SEQUOYAH NUCLEAR PLANT (SQN) UNITS 1 AND 2

(TVA-SQN-TS-95-11, REVISION 1)

DESCRIPTION AND JUSTIFICATION FOR

REVISION OF OVERTEMPERATURE AND OVERPOWER

FIGURE 5

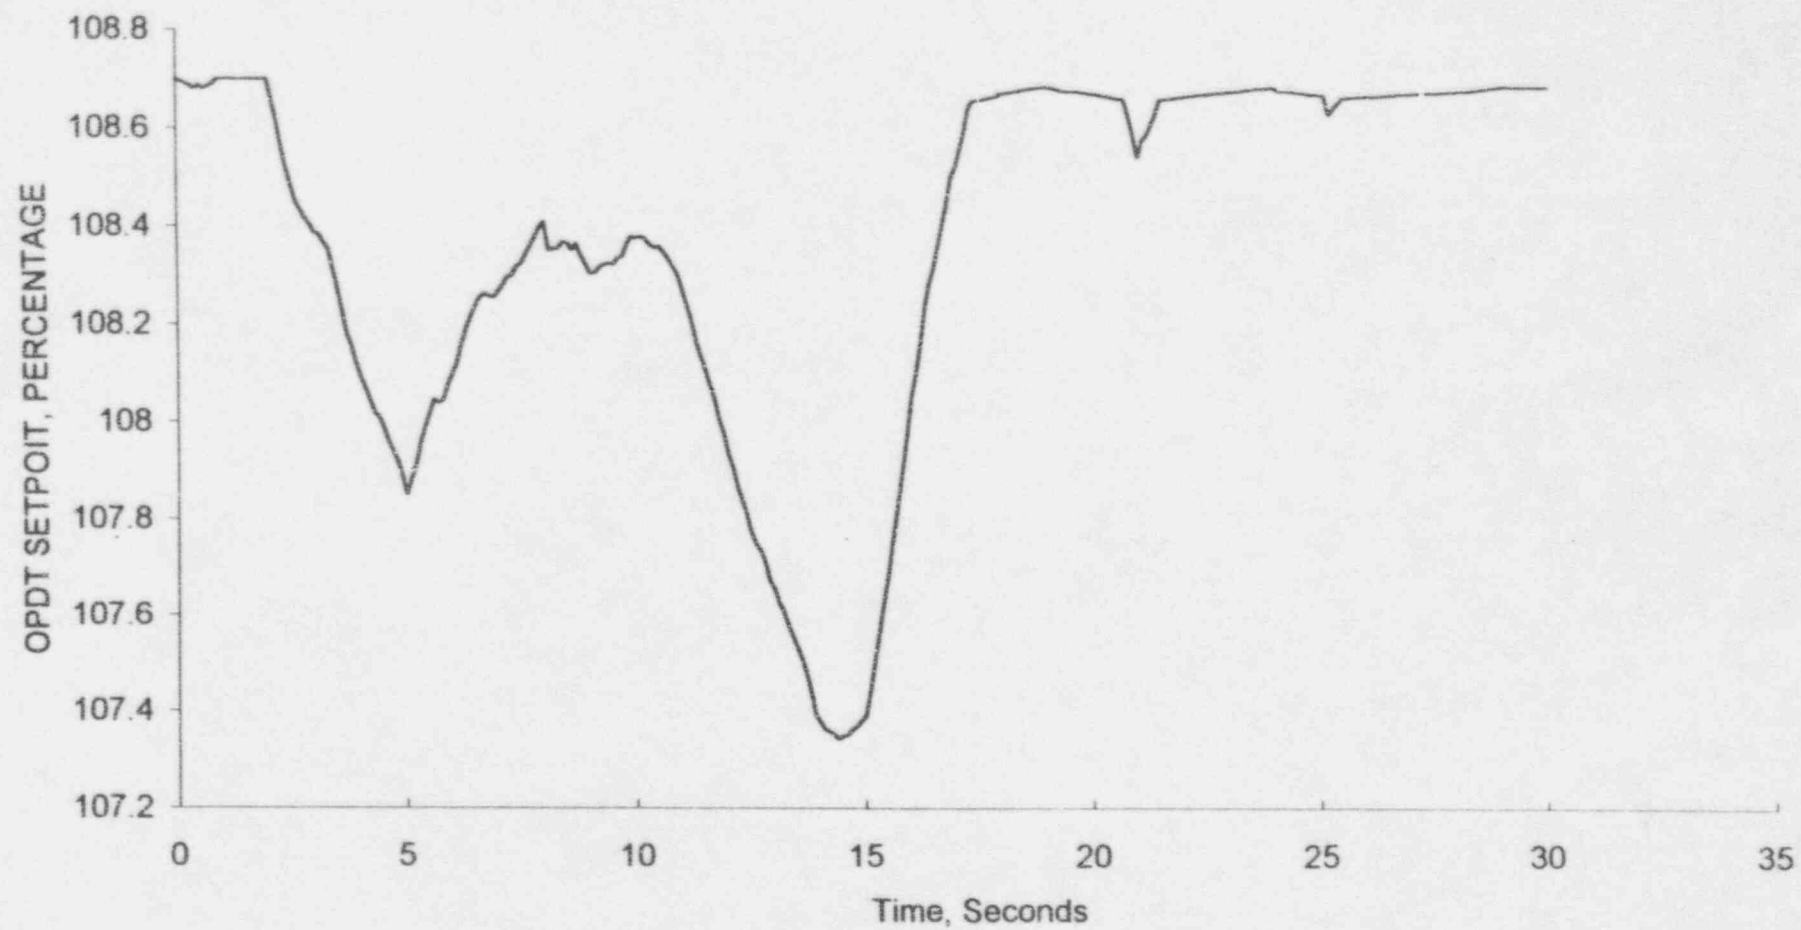
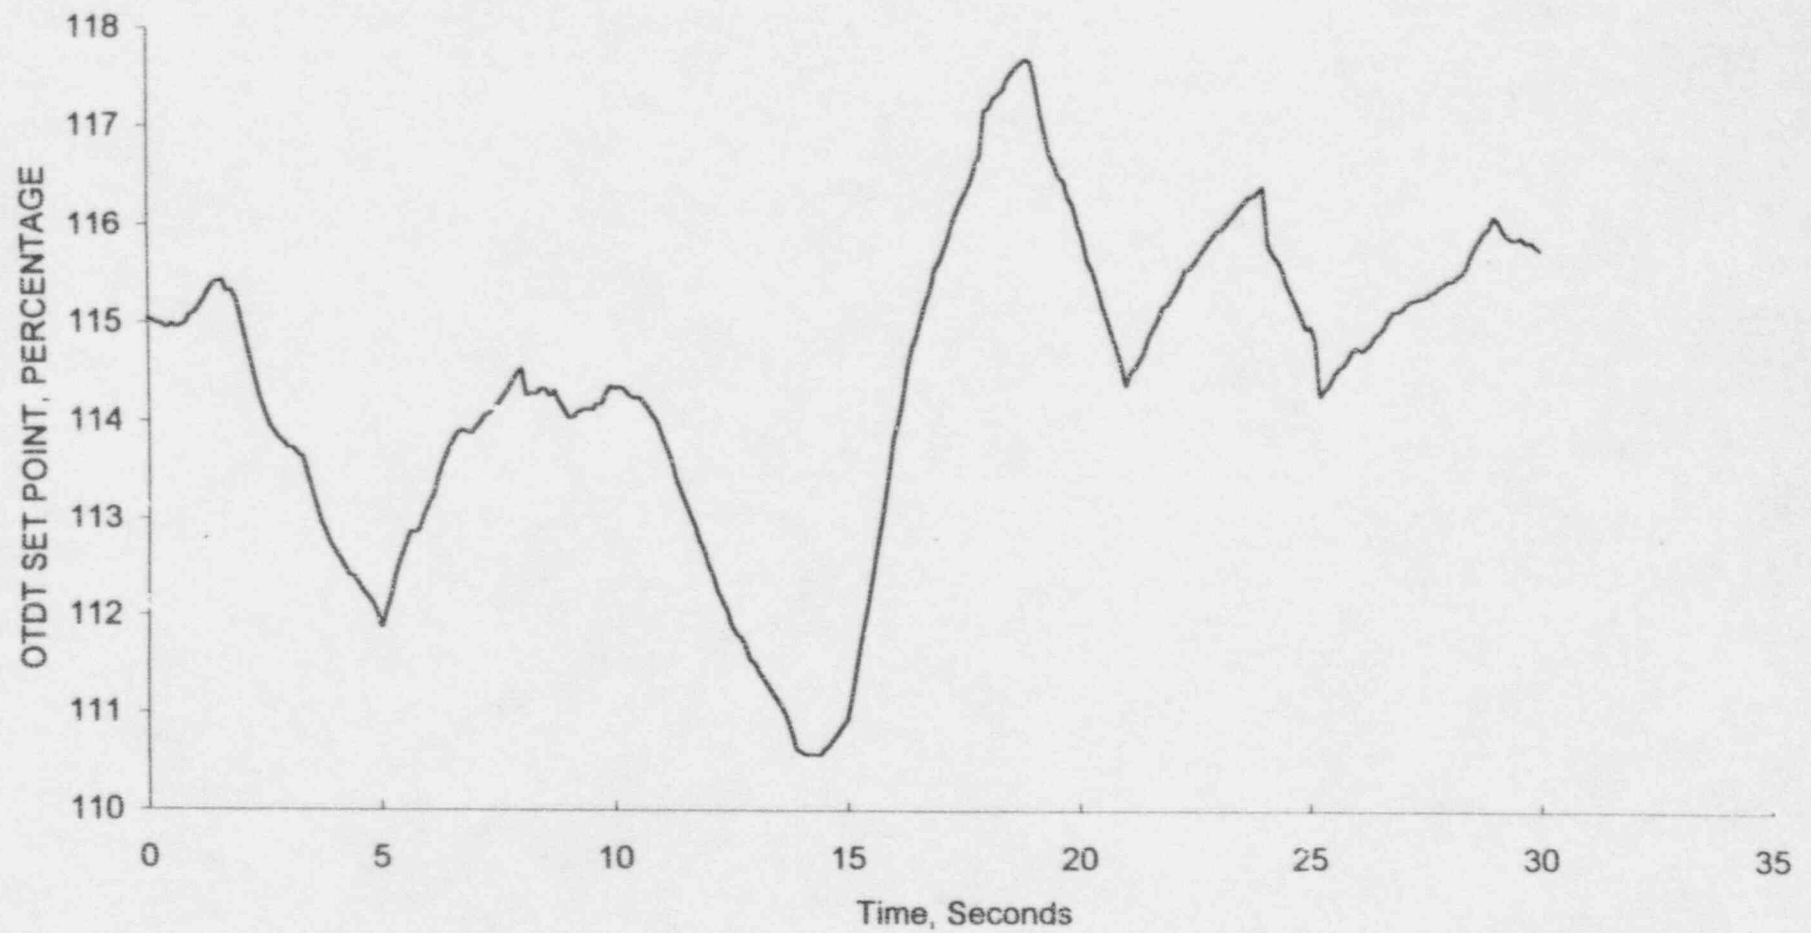
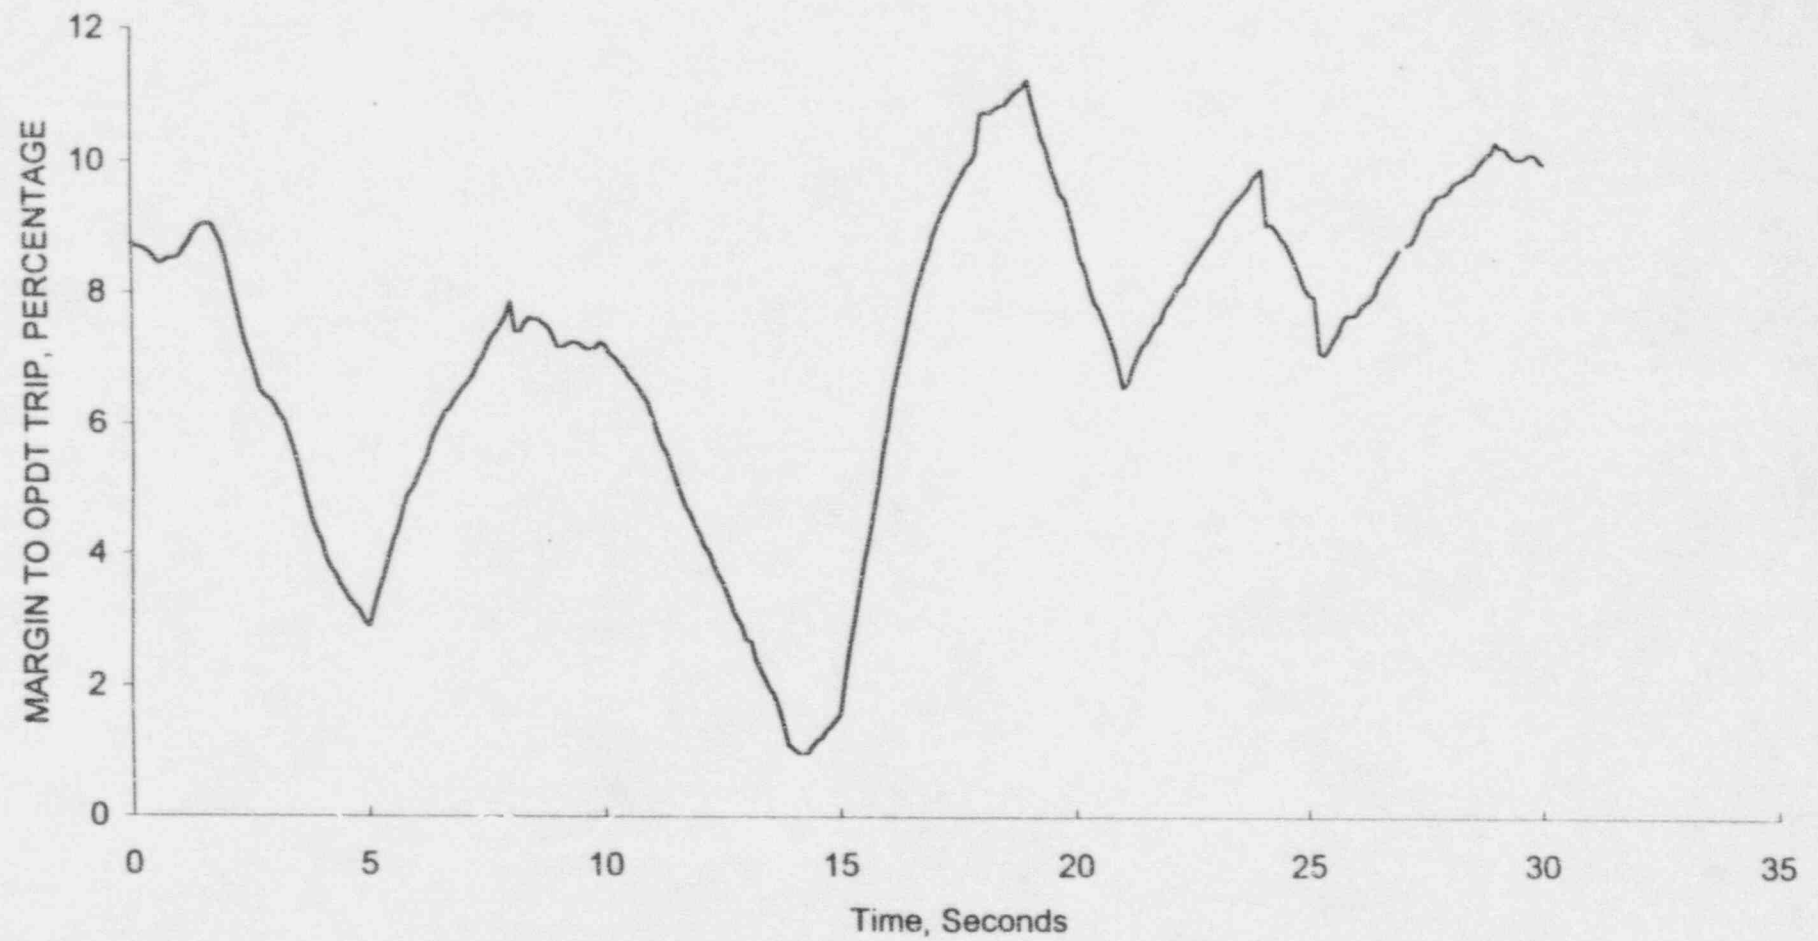
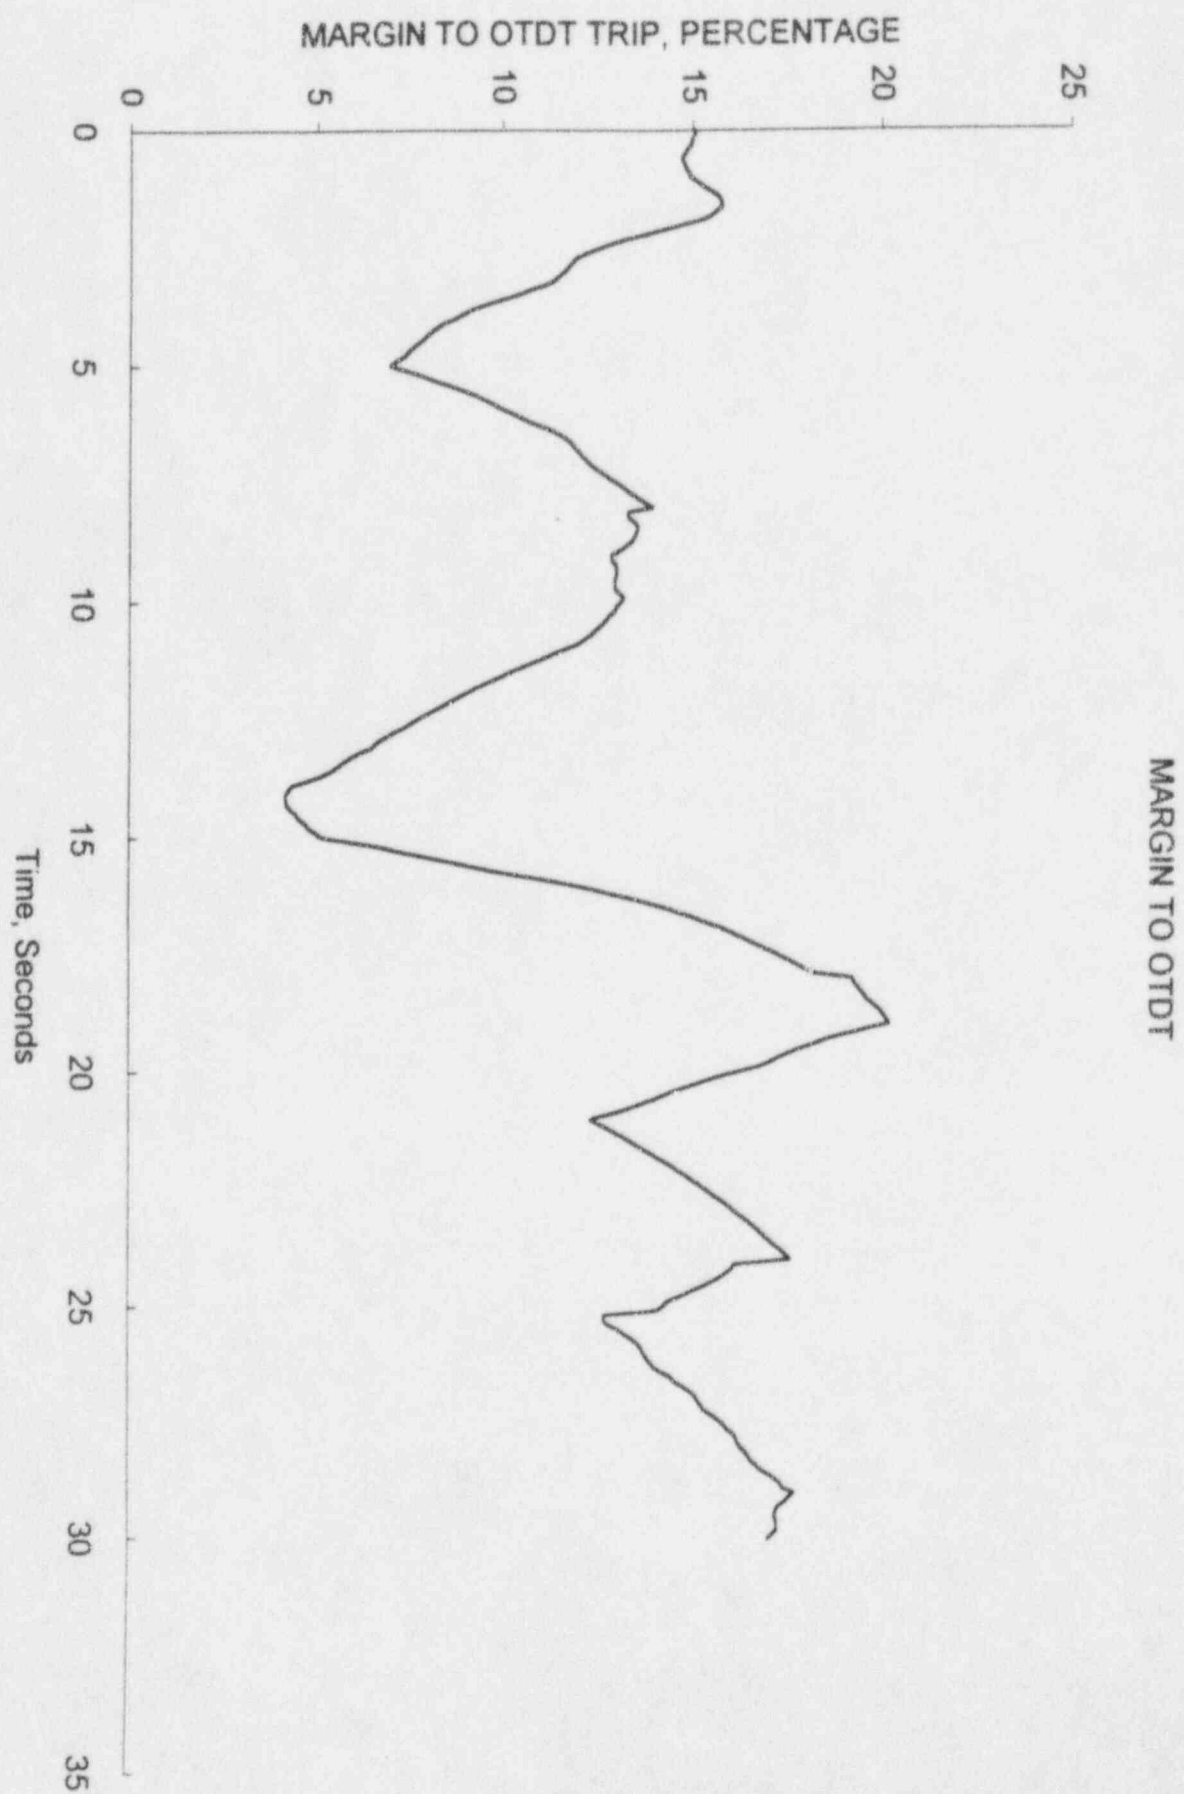
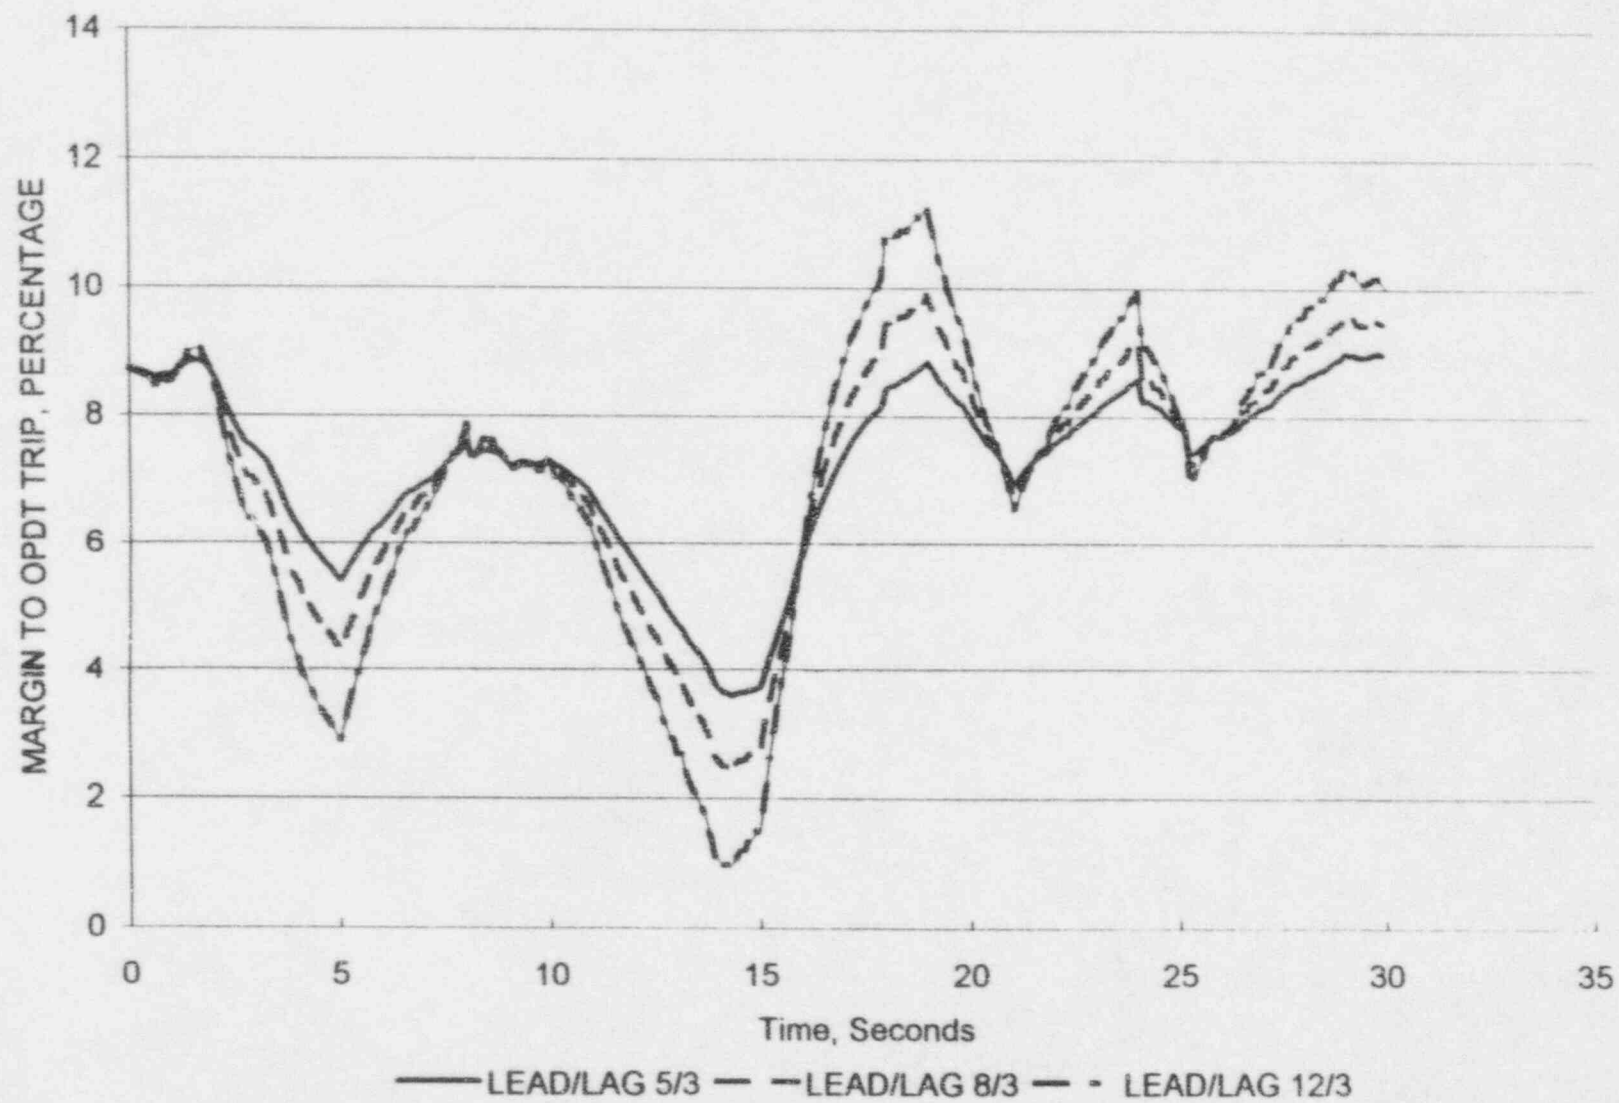
The hypothetical RTD signals are shown in Figure 1. It should be noted that there are several combinations of the temperature ramp rate and maximum amplitude that would result in a one percent OPΔT margin. The T-hot RTD signals shown in Figure 1 have a rise time of four seconds, a typical RTD time constant. If the rate of increase is higher than that simulated, a smaller temperature increase would result in OPΔT alarms/trips. Also, if the actual rate of temperature increases are lower than that simulated, the margin recovered will be more than that determined with a four second rise time.

The hypothetical T-hot signature is shown in Figure 1. The T-hot average (Figure 2) and T-avg (Figure 3) are then determined using a corresponding T-cold. The delta-T calculated from the above T-hot/T-cold variations are shown in Figure 4 along with the lead/lag compensated delta-T for a lead/lag ratio of 12/3. This lead/lag delta-T is compared with the OPΔT/OTΔT setpoints (Figures 5 and 6) to calculate the margin to OPΔT/OTΔT (Figures 7 and 8). As shown in Figure 7, the current OPΔT margin is about 1%. The same temperature fluctuations are used to calculate OPΔT margin for a lead/lag ratio of 8/3 and 5/3 (Figure 9).

The results are shown in Table 1. If the lead/lag ratio is reduced from 12/3 to 5/3, the OPΔT margin increased from 1.0% to 3.6%.
